Grant Spacing Signaling at the ONU

Glen Kramer, Broadcom
Duane Remein, Huawei

Overlapping Grants to the same ONU

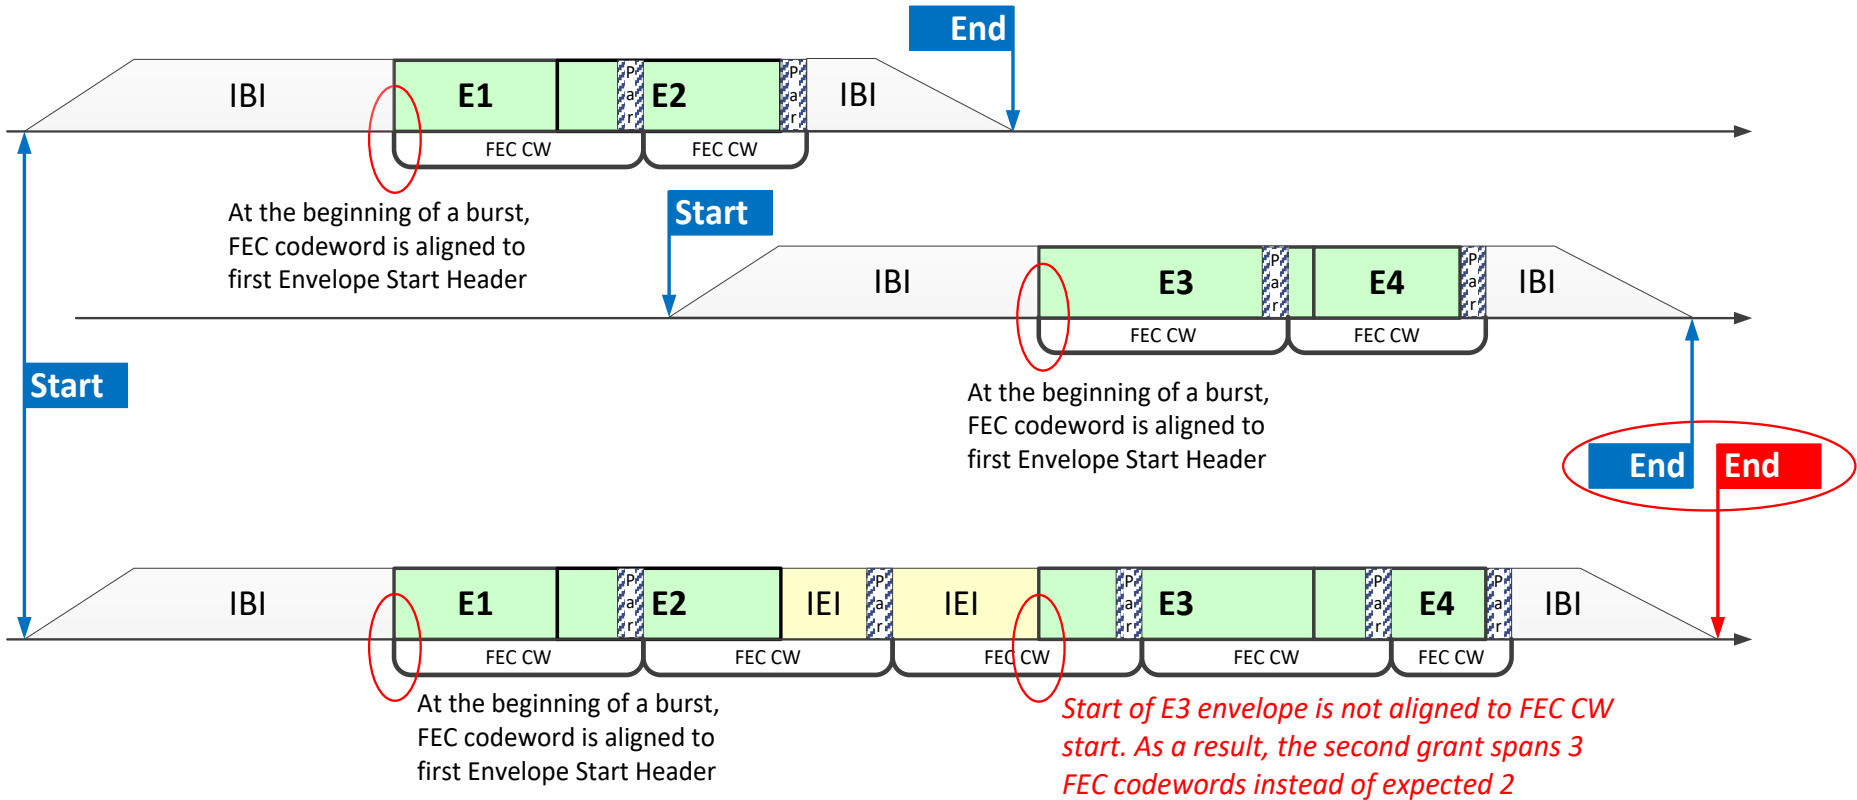
- Bad things happen if the OLT grants two overlapping bursts (i.e., Burst #2 StartTime < Burst #1 EndTime)

- Start of E3 envelope (second burst) is not aligned to FEC CW start. As a result, in this example, the second grant spans 3 FEC codewords instead of the expected 2. This causes the end of the combined burst expand past the expected end time by one full parity region (10x257b blocks or ~100 ns)

Figure 144-16—Envelope Activation Process state diagram

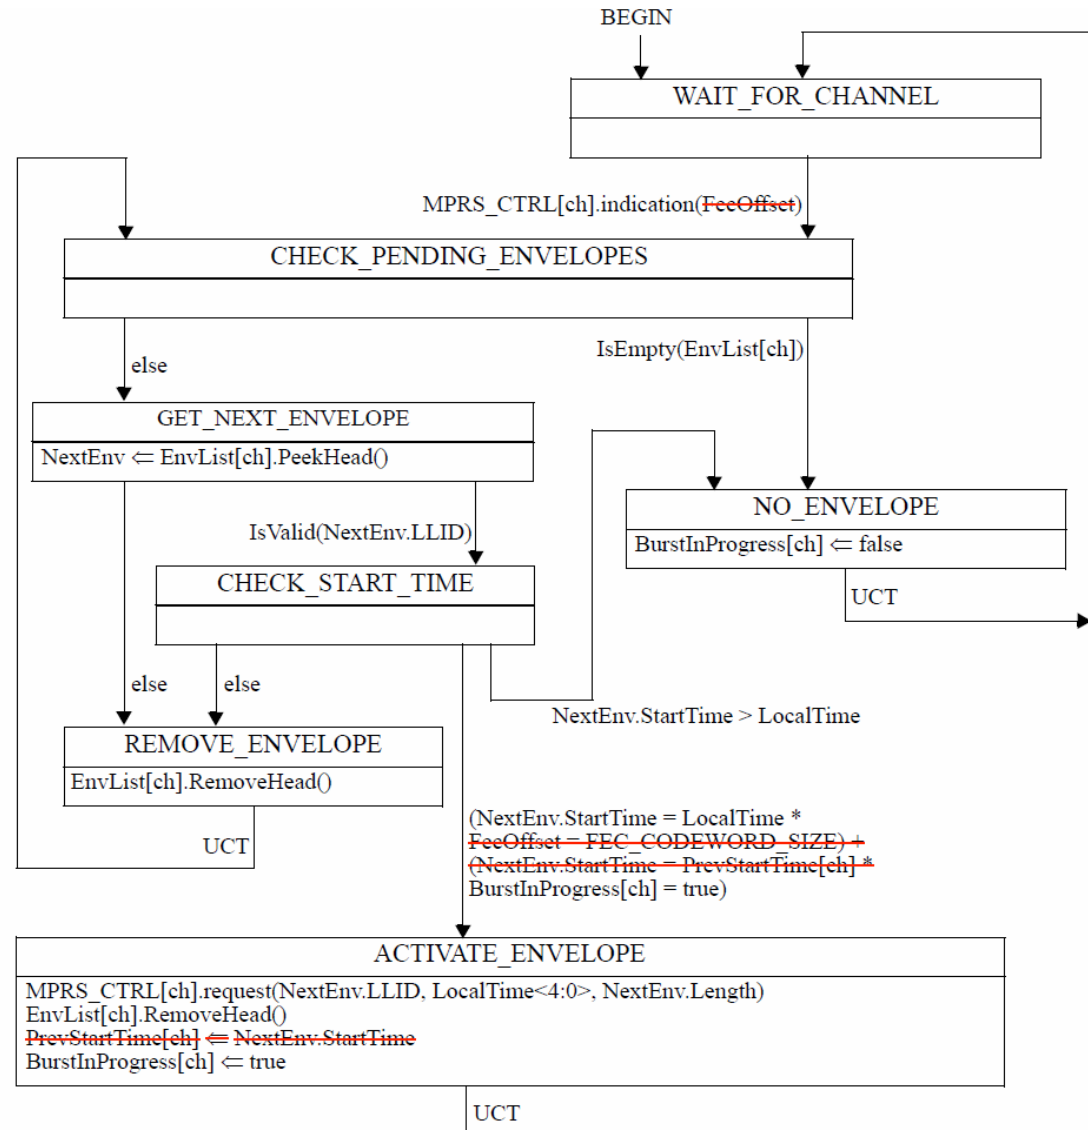
- ❑ Don't need to be aware of FEC CW alignment
 - No need to receive FecOffset from MPRS
- ❑ Don't need to keep track of StartTime of previous envelope
- ❑ Simpler transition into ACTIVATE_ENVELOPE state.

New Envelope Activation SD

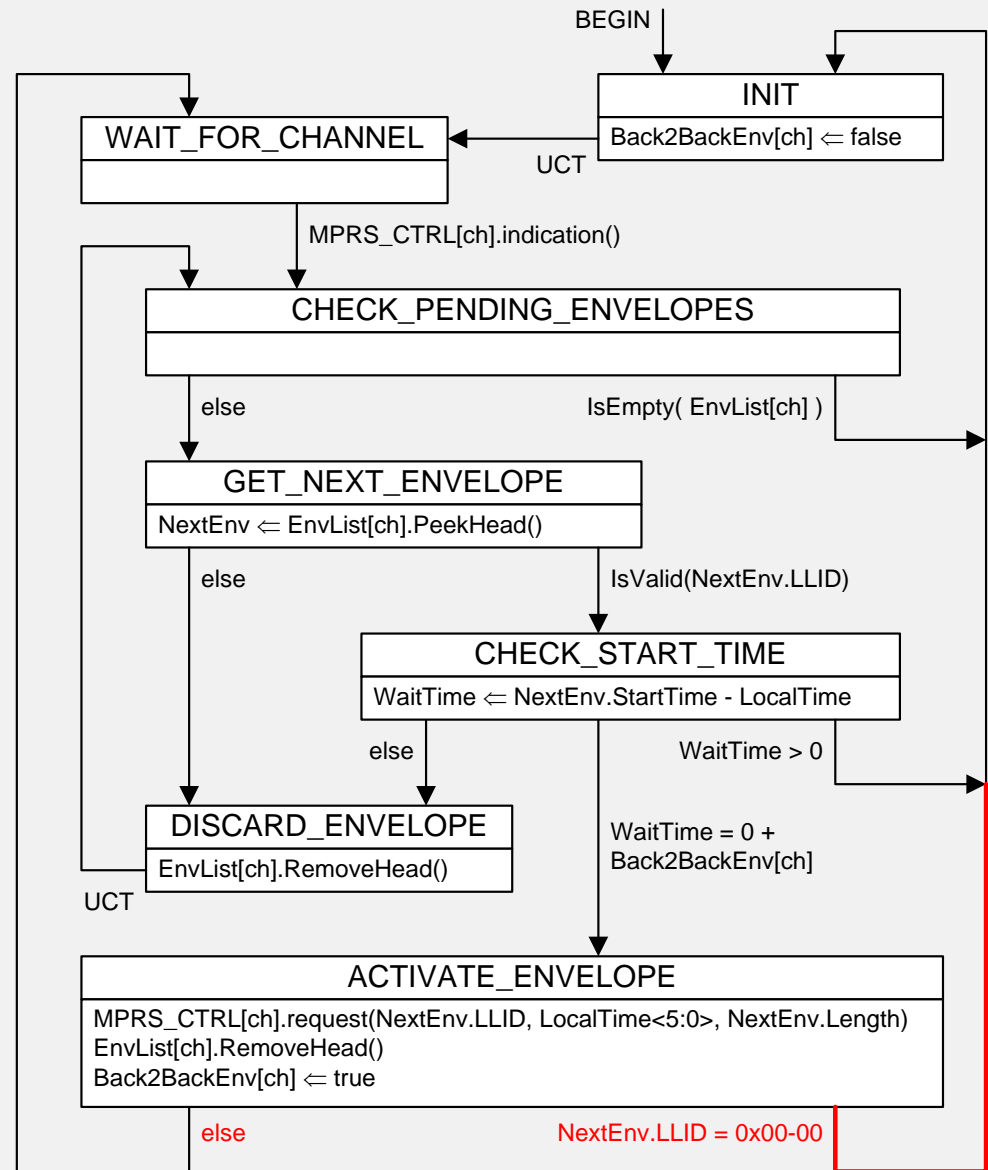
- ❑ The same SD is used in the OLT and ONUs
- ❑ Added transition from ACTIVATE_ENVELOPE TO INIT to explicitly signal the end of burst, so that the next burst can only start when its *StartTime == LocalTime*

MPRS Input SD

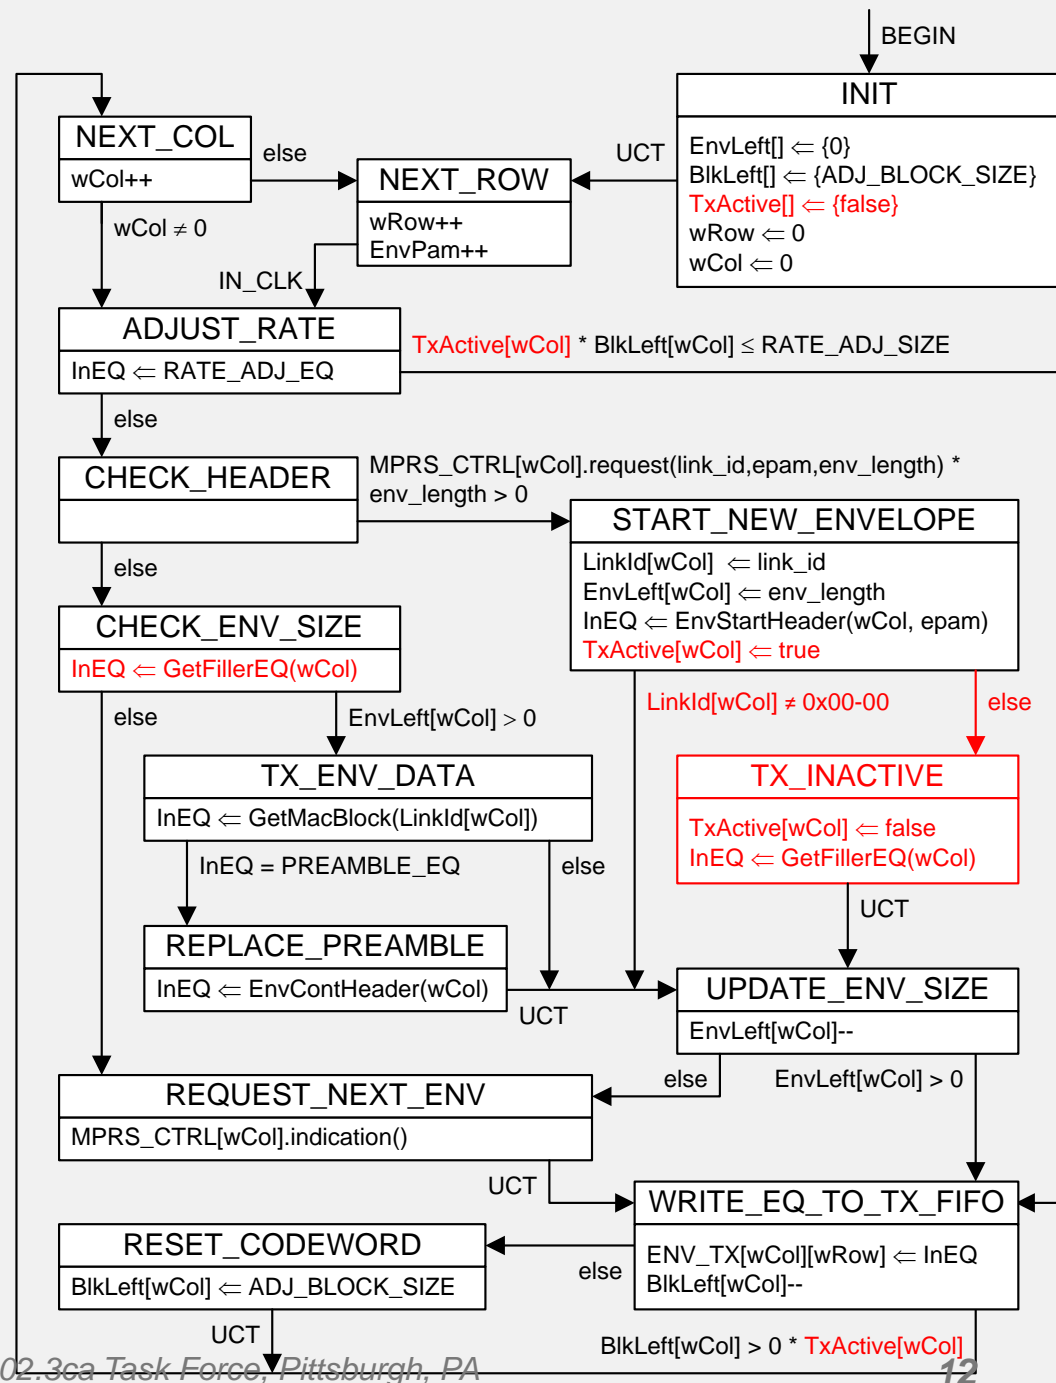
- Added state TX_INACTIVE to process TEDs
- New behavior:** When TED is received, MP RS Input Process starts generating Inter-Burst Idles (IBI_EQ) toward the 25GMII and it does not ask MPCP for a new envelope until the envelope length worth of IBI_EQ is generated.
- Another (non-essential) change is to rename FEC-related constants (MP RS as a layer does not need to be FEC aware, but instead should be capable of rate adjustment.)
 - PARITY_PLACEHLDR → RATE_ADJ_EQ
 - FEC_CW_SIZE → ADJ_BLOCK_SIZE
 - FEC_PARITY_SIZE → RATE_ADJ_SIZE
